ACRS-1718

MEETING MINUTES OF THE COMBINED
ACRS ECCS/REACTOR FUEL SUBCOMMITTEE MEETING
FEBRUARY 14, 1980
WASHINGTON, D. C.

On February 14, 1980 the Combined ACRS ECCS/Reactor Fuel Subcommittee met in Washington, D.C., to discuss the effects of externally mounted thermocouples on the LOFT fuel rods, and proposed changes in the ECCS fuel cladding rupture models for Appendix K to 10 CFR 50.46, and the effect of these changes on vendor's evaluation models. The notice of the meeting appeared in the Federal Register on January 30, 1980. There were no requests for oral or written statements from members of the public and none were made at the meeting. Attachment A is a copy of the meeting agenda. The attendees list is Attachment B. Attachment C is a tentative schedule of presentations for the meeting. Selected slides and handouts from the meeting are Attachment D to these minutes. A complete set of slides and handouts is attached to the office copy of these minutes.

JAERI MRBT Heating Element

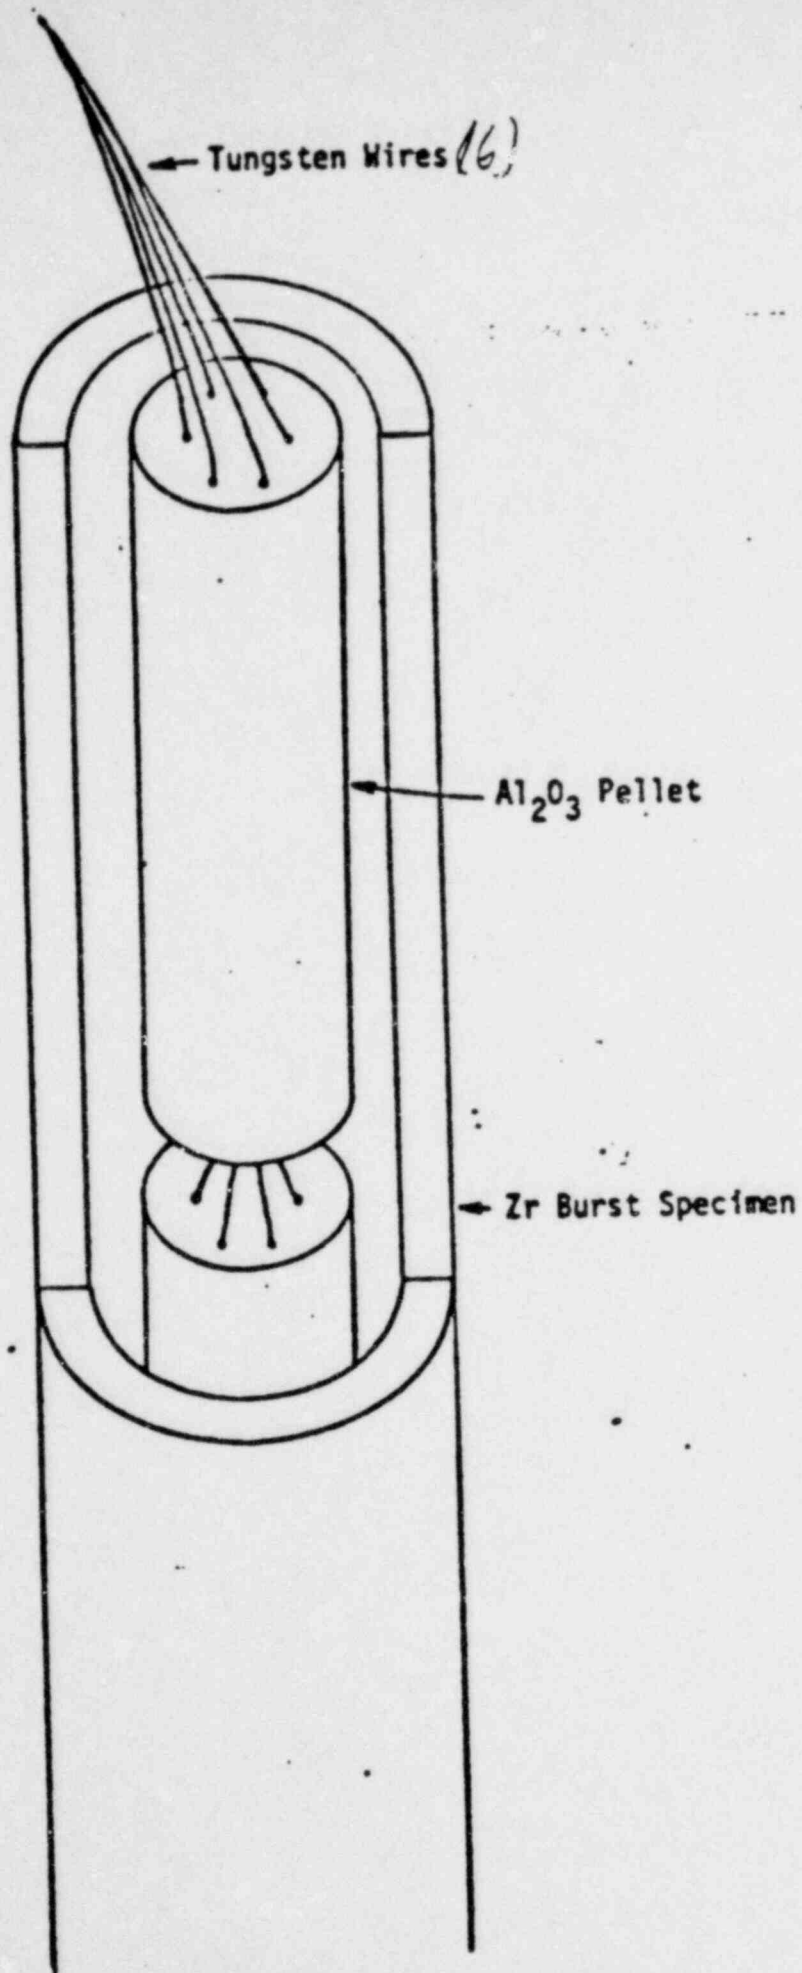
In describing the flow blockage correlations, Mr. Burman referenced some Japanese multi-rod burst tests that resulted in a large degree of co-planar blockage (Figures D-22-23). Mr. Burman said he believed this co-planar blockage was the result of the tungsten wire electrical heating element used (Figure D-24). (Note: Dr. Kawasaki was contacted by NRC concerning Mr. Burman statement regarding cause of the co-planar blockage. Dr. Kawasaki said that he does not believe the heater design was the cause of the co-planar blockage.

Rather it was probably due to effect of the steam flow and/or the grid spacers used in the experiment.) Westinghouse believes their flow blockage model is sufficiently conservative.
